Subject: FW: Burwood Ave project needs another crosswalk!

Subject: Burwood Ave project needs another crosswalk!

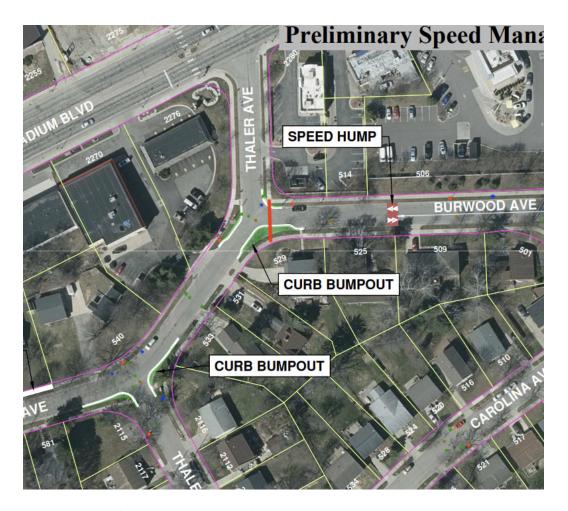
However, there's one really important thing that seems to be missing - there's not a single crosswalk across Burwood between Liberty and Fair in the plan (nor is there one in the current built environment of that corridor). This really needs to change; that's an awfully long distance to go without a safe, ADA compliant crossing, especially for a neighborhood street. It seems to me that the most useful place to put one would be at (the northern branch of) Thaler - where I put the red line in this illustration:
